Re: Township of Westtown
Conditional Use Application of Toll PA XVIII, L.P. for the Crebilly Farm

**WESTTOWN TOWNSHIP PLANNING COMMISSION'S
PROPOSED FINDINGS OF FACT AND CONCLUSIONS OF LAW**

Page: 6
Re: Conditional Use -- The Robinson Tract
Westtown Township - CU-09-19-16071

Figure 3: Brandywine Battlefield Swath, Approximate troop movements and battlefield skirmishes

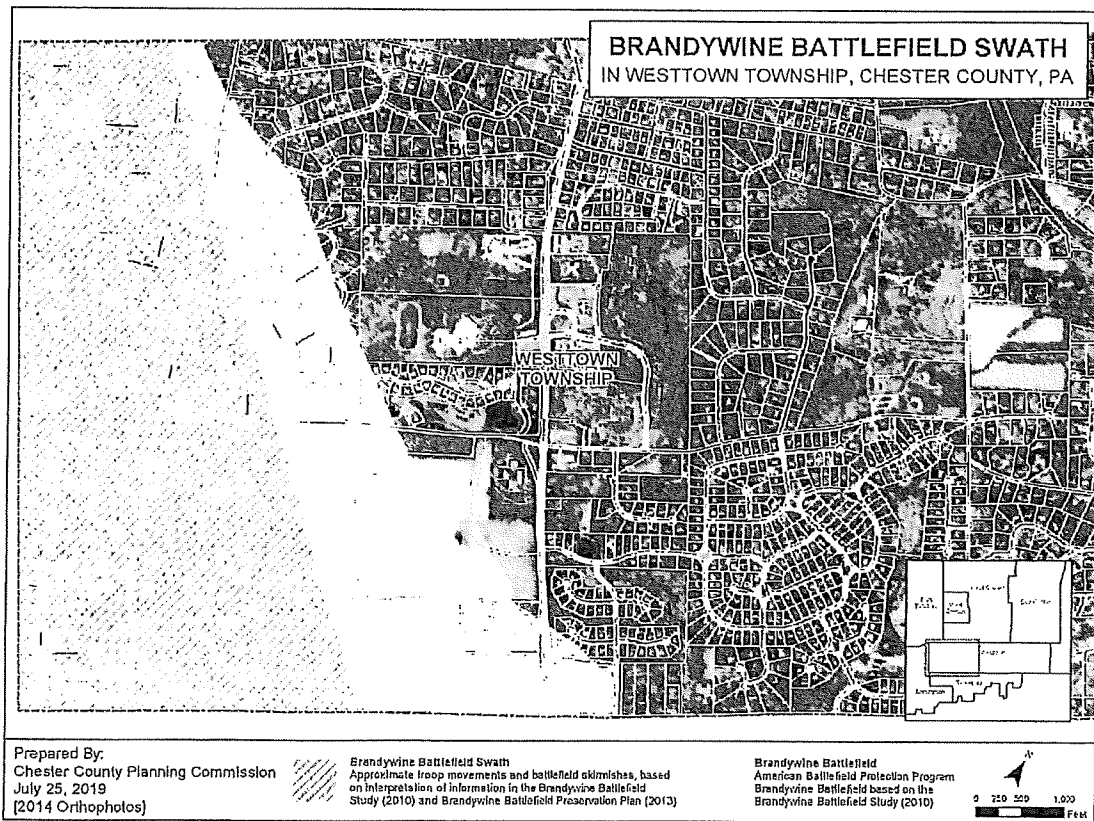
- 22) Prior to issuance of grading permits, Applicant shall cause to be conducted an archeological survey including ground penetrating radar survey of any areas proposed to be disturbed within the Brandywine Battlefield Swath which is depicted on the CCPC review letter dated October 18, 2019, Figure 3. Applicant shall share the

- 1) The flexible development shall contain a maximum of 319 dwelling units, which shall include the two existing dwellings on the Property.
- 2) Applicant shall revise the Revised Alternate Plan to further mitigate detrimental impacts to important scenic and historic resources on the Property by shifting all development out of what has been identified as the Brandywine Battlefield Swath in a Chester County Planning Commission review letter dated October 18, 2019, Figure 3.
